TELEPHONE SETS
MODIFICATION FOR SECOND PARTY SATT DETECTION
RESISTIVE GROUND METHOD

1.01 This addendum to Issue 2 of this section adds information to modify the Type 80E, 85E, 182B, 192A, 192B, 981, and 982 telephones for second party SATT detection.

Figure 3. AEC Co Types 80 and 90M—Manually Adjusted, Bridged or (-) Grounded Ringing.

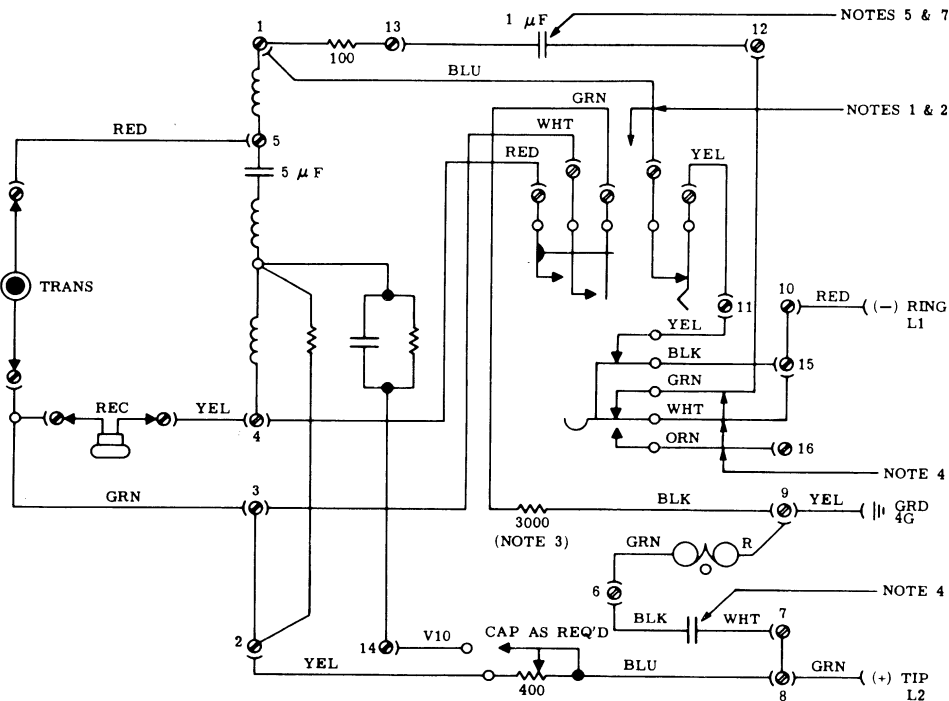
2.04 Change the title of Figure 3 to read as follows: "AEC Co Types 80, 80E, and 90M - Manually Adjusted, Bridged or (-) Grounded Ringing."

2.05 In Figure 3, change terminal "3" to terminal "23."

Figure 4. AEC Co Types 80 and 90M—Manually Adjusted, Divided Ringing (+) Tip to Ground.

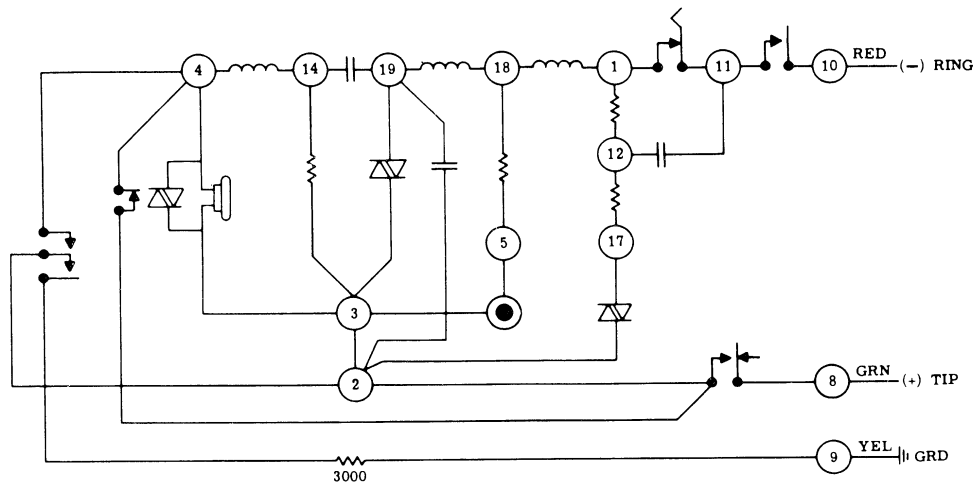
2.06 Change the title of Figure 4 to read as follows: "AEC Co Types 80, 80E, and 90M - Manually Adjusted, Divided Ringing (+) Tip to Ground."

2.07 In Figure 4, change terminal "3" to terminal "23."

Figure 5. AEC0 Types 80, 85, 86, 87, 90M, 182, 183 and 880—Self Compensating.

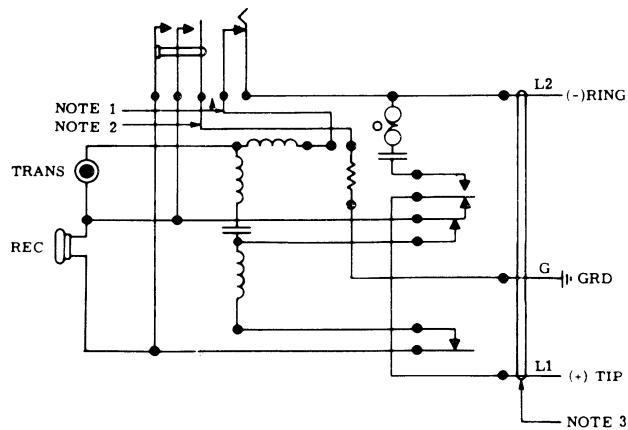
2.08 Change the title of Figure 5 to read as follows: "AEC Co Types 80, 80E, 85, 85E, 86, 87, 90M, 182A, 182B, 183, 192A, 192B, 880, 981, and 982 - Self Compensating."

2.09 In Figure 5, change terminal "3" to terminal "23."
